**SUBJECT:** **NEW VEHICLE DEMONSTRATION / DELIVERY HOLD**  
**Compliance Recall 21C06 – Supplement #2**  
 Certain 2020 - 2021 Model Year F-150 and Super Duty Vehicles  
 Windshield Glass Reattachment

**REF:** **Compliance Recall 21C06 – Supplement #1**  
 Certain 2020 - 2021 Model Year F-150 and Super Duty Vehicles  
 Dated: June 3, 2021

**New! REASON FOR THIS SUPPLEMENT**

- **Attachment III:** Minor changes for clarification on which steps are required for Lead Foot Gray versus all other colors.
- **Attachment IV:** Minor changes for clarification how to better protect the central roof body paint and which primer to use in specific locations.

**FIGURE 1**

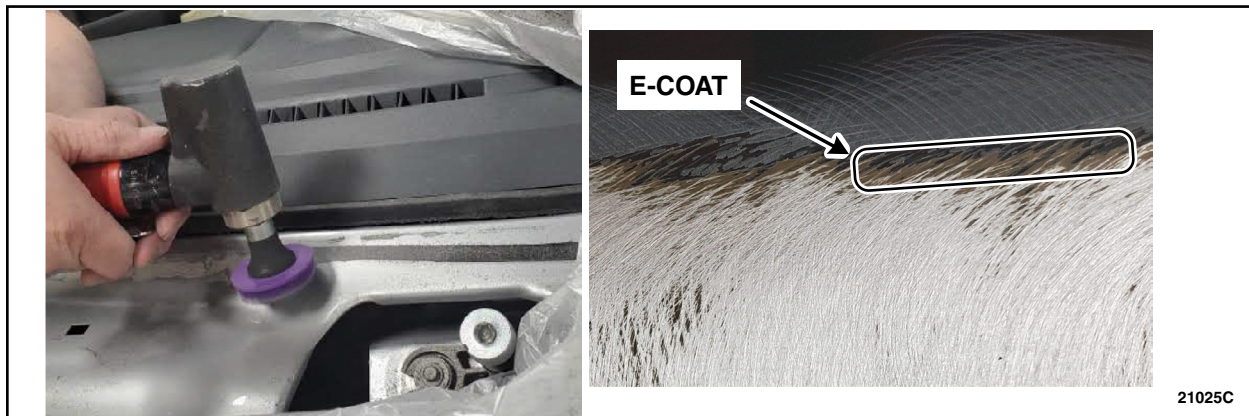
1. Cover/protect the body and interior of the vehicle.
2. Is the vehicle Lead Foot Gray?  
Yes – Proceed to Step 3.  
No – Proceed to Steps 4-6.
3. Using a Scotch-Brite 3M Roloc disk, remove all the urethane, clear coat, base coat, and paint primer only where the urethane will be applied around the entire windshield body flange perimeter. The goal is to expose the e-coat without going down to bare metal. See Figure 1.

**FIGURE 5**

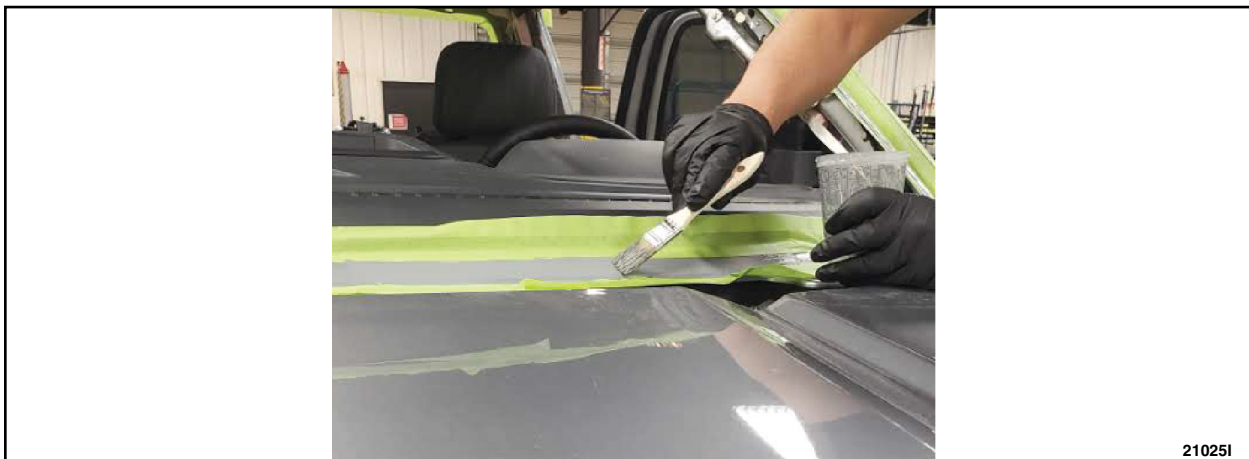
10. Apply one coat of any Ford approved epoxy based repair primer to any spots where the roloc disk was used to grind off the urethane. Allow time for the primer to dry per the manufacturer's instructions. See Figure 5.

***NOTE: This step applies to Lead Foot Gray ONLY.***

**FIGURE 17**

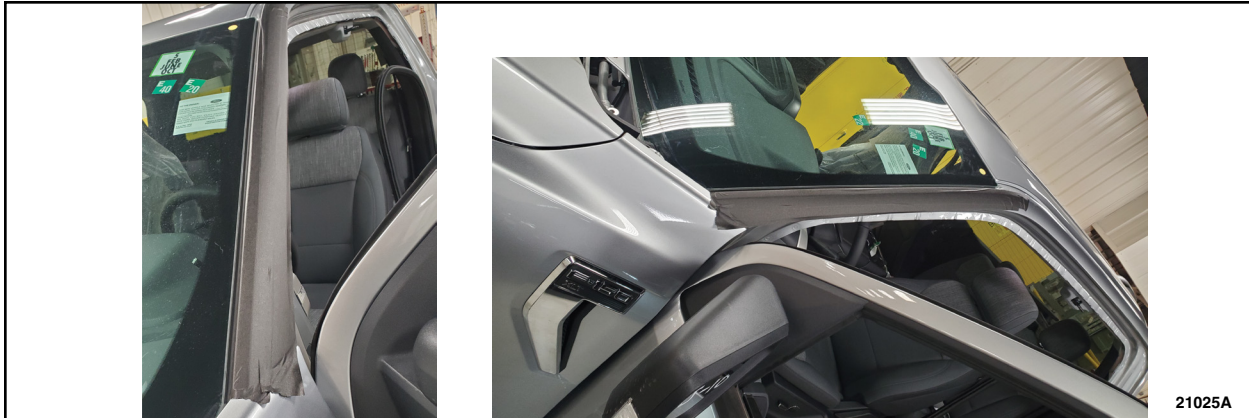
17. Apply tape to the perimeter of the windshield to protect from paint damage. See Figure 17.

**NOTE:** *Tape off the roof panel near the centerline of the vehicle, where the roof extends forward. When using a piano wire to cut out the glass, the wire will roll over the class A paint in the roof area, once tension is applied to it. If using a nylon style string, this will not damage the paint.*
